WATER POLLUTION CONTROL AUTHORITY
Town of Trumbull
CONNECTICUT

JANUARY 14, 2026
MINUTES

SUBJECT
Wildwood Pump Station
 Confirmation of Existing Conditions and Alternatives Review

Date: **12/18/2025**Project No.: **20718B**To: **William Maurer**From: **Christine Kurtz and Joe Hausmann**Subject: **Sewer Capacity Request Review Comments – 2135, 2145 & 2155 Reservoir Ave**

Figure 1. Option 1 plan view.

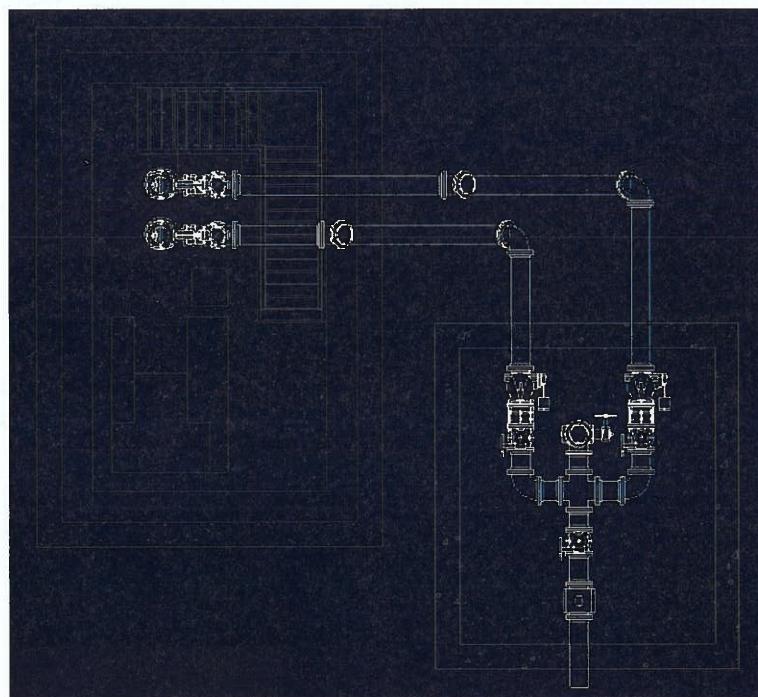
Option 1: New Submersible Pumps in Existing Wet Well

This alternative involves reconfiguring the existing wet well to accommodate new submersible pumps, along with installation of new piping, valves, and appurtenances to connect to the existing force main. Review of as-built drawings indicates sufficient space for two new submersible centrifugal pumps within the wet well, but insufficient space for the required isolation and check valves. Consequently, a separate concrete valve vault (approximately 10' x 12' x 11' deep) would be constructed to house these components. Locating valves in a separate structure is also advantageous due to the corrosive atmosphere in the wet well.

Construction would require demolition of the entrance to the existing dry pit and filling in the structure to support the new valve vault. Additional modifications to the wet well would include:

- Creating new openings in the top and intermediate slabs for pump maintenance access.
- Installing a baffle wall to improve hydraulic conditions and reduce air entrainment.
- Partially filling the wet well to improve flow toward the pumps and minimize dead spots.
- Creating wall penetrations for piping from each pump to the valve vault.
